MEMORANDUM

Date: January 06, 2015
To: David Bonk, Kumar Neppalli, PE
Town of Chapel Hill, North Carolina
From: Bill Schultheiss, PE
Re: South Columbia Street and Otey's Road Safety Review and Concept Development

Toole Design Group (TDG) was retained by the Town of Chapel Hill to review a concept design developed by Kimley-Horn and Associates, Inc. (KHI) at the northern intersection of South Columbia Street at Fordham Boulevard (attached as exhibit 2), to develop concept design alternatives for South Columbia Street from Purefoy Road to Culver Road, and to develop a crossing improvement concept for Otey's Road at Fordham Boulevard.

SHEET NAME:
 Oteys Road
 Proposed Condition
 DRAWING NUMBER
SK-11
 SHEET NUMBER
11 OF **13**

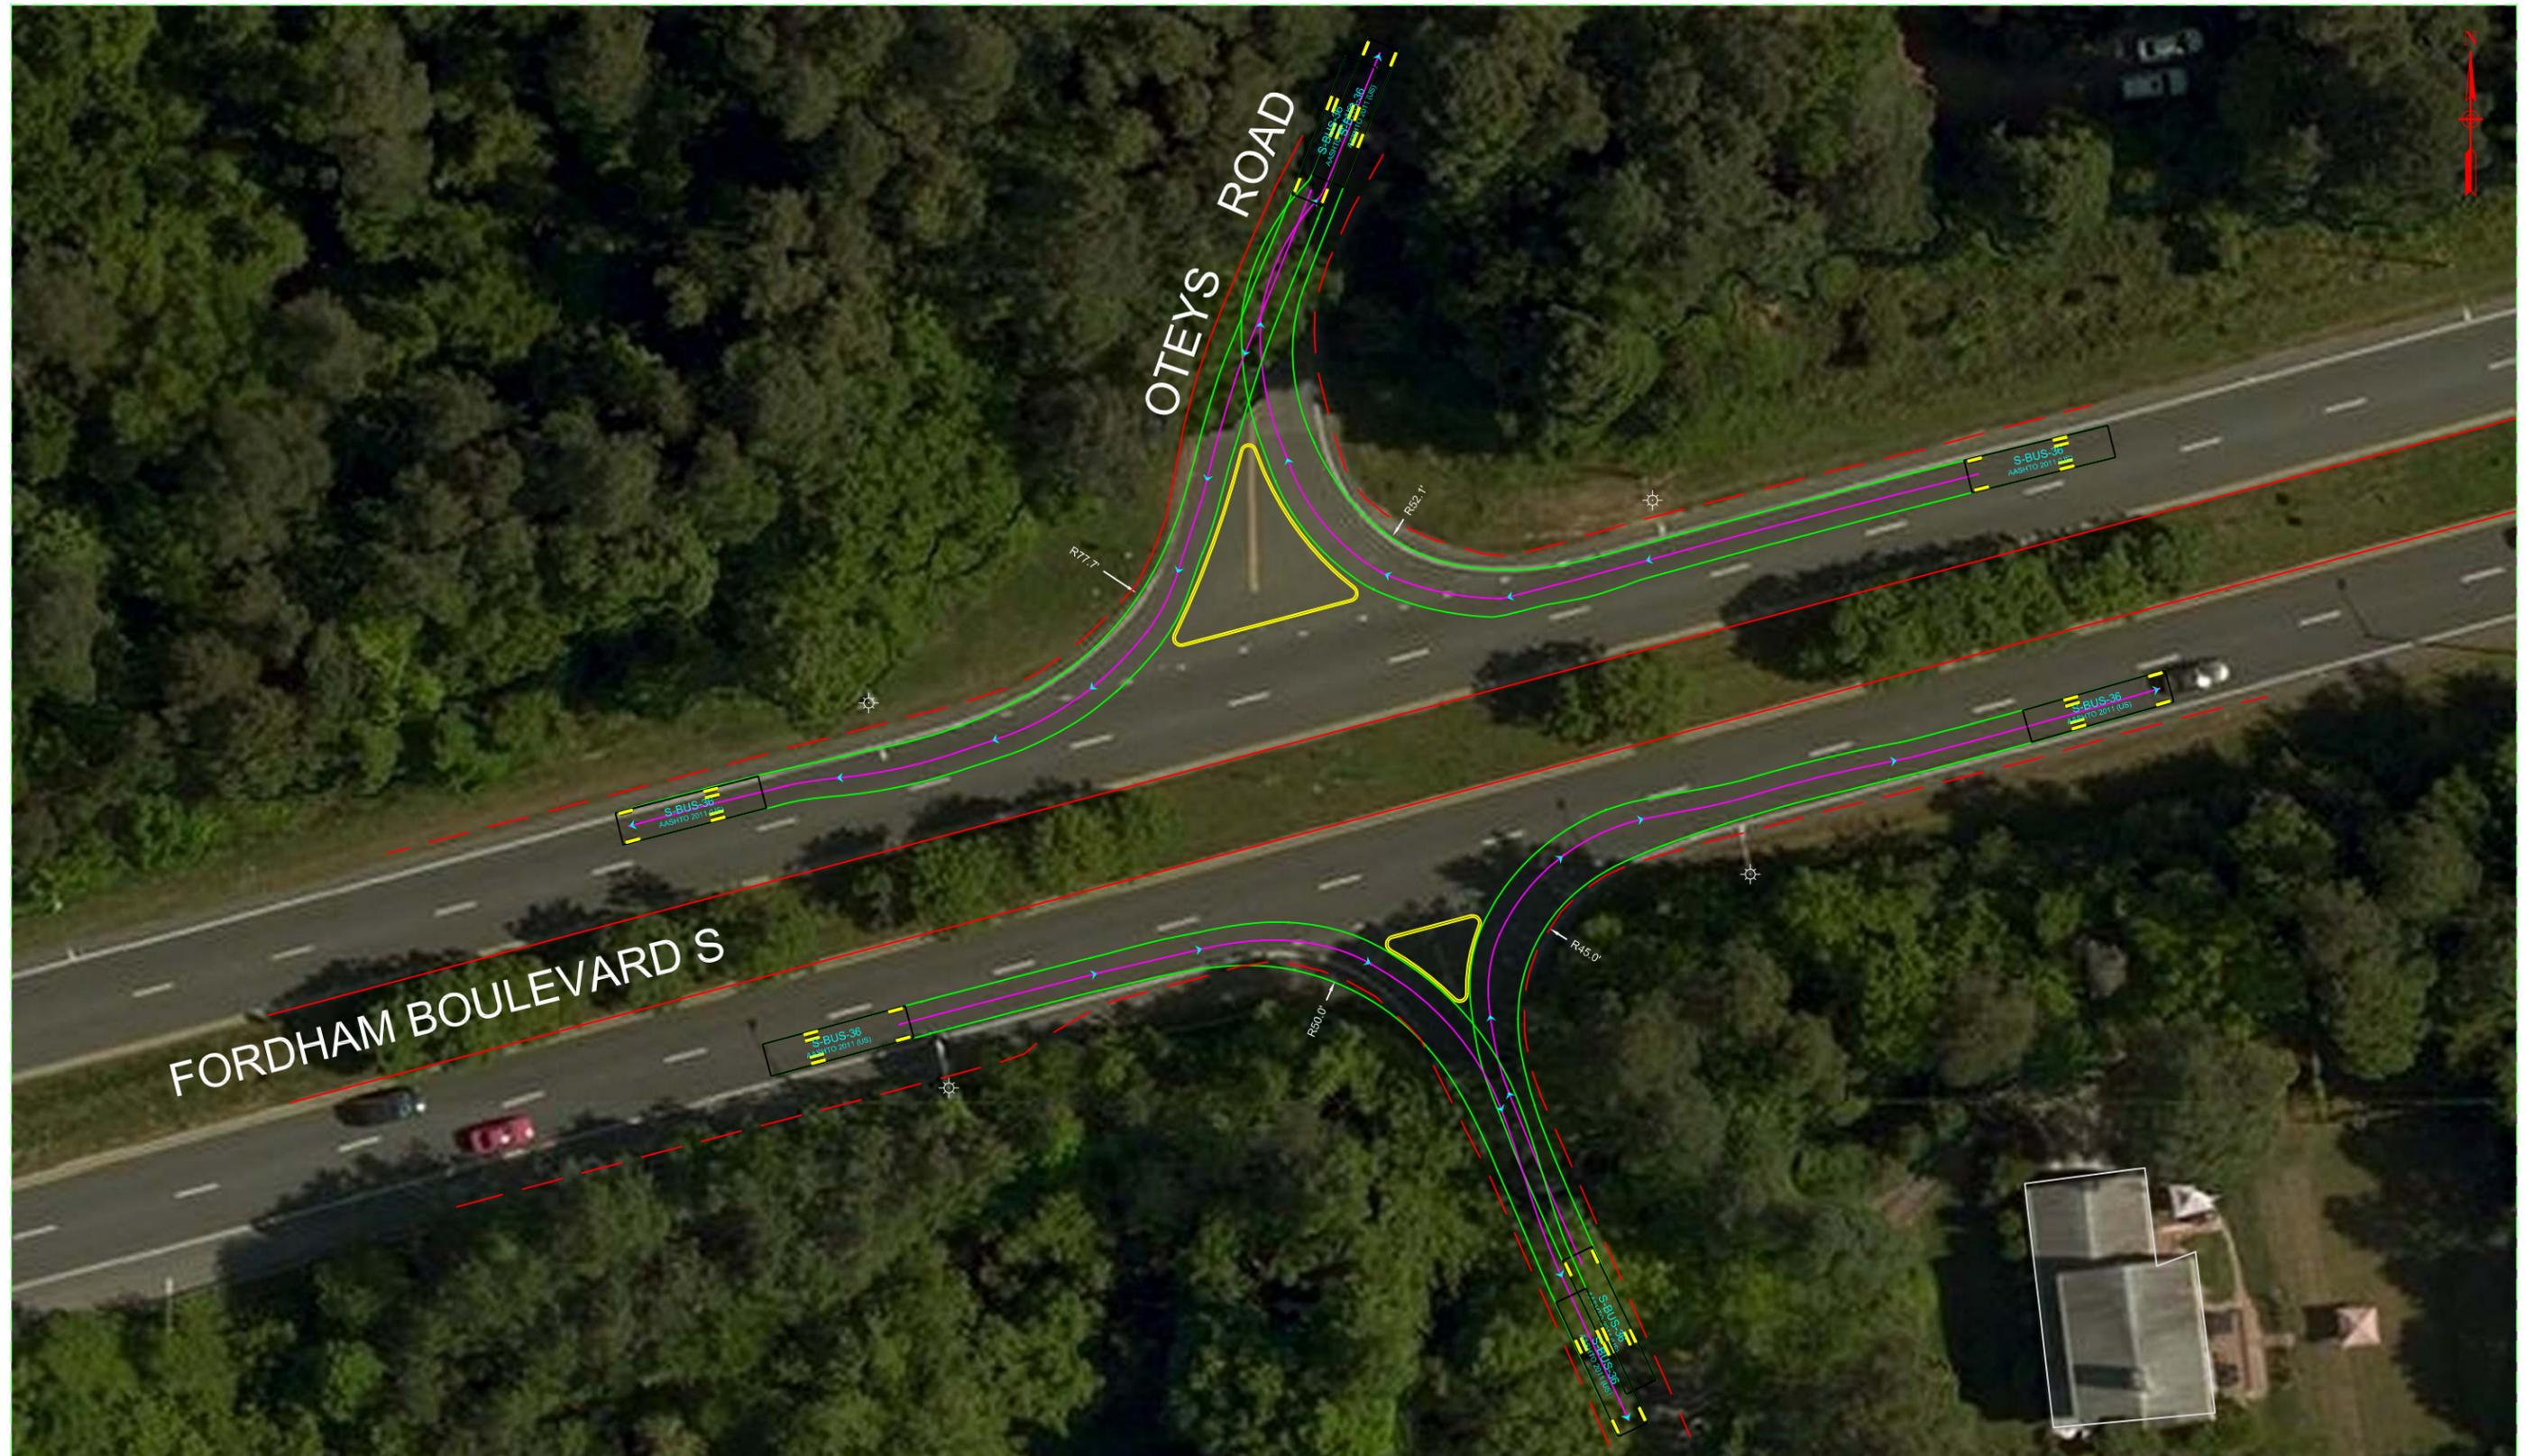
The Town and UNC bicycle plans recommended development of a pedestrian and bicyclist crossing of Fordham Boulevard. Provision of a safe crossing at this location would create an additional crossing between South Columbia Street and Manning Drive for non-motorized travel. Fordham Boulevard acts as a significant barrier to non-motorized travel as Manning Drive and South Columbia streets are separated by more than one mile. To safely cross Fordham Boulevard it will be necessary to modify the median to provide refuge, channelize traffic turning onto and off from Fordham Boulevard, and to install a traffic signal to stop traffic on Fordham Boulevard. The traffic signal can potentially be Pedestrian Hybrid Beacon or a full traffic signal. Given the lower volume of pedestrian and bicycle traffic likely this location it is recommended a relatively hot response be provided to reduce the likelihood of users crossing against the light as gaps in traffic appear. The maximum wait time is suggested at 30 seconds. If this is not achievable, it is advisable the signal at least be coordinated with the signal at Manning Drive.

- Crossing island improvements for bicyclist and pedestrians within the median
- Sidewalk improvements
- Proposed location for channelizing islands on Otey's Road
- Proposed HAWK signal on Fordham Boulevard
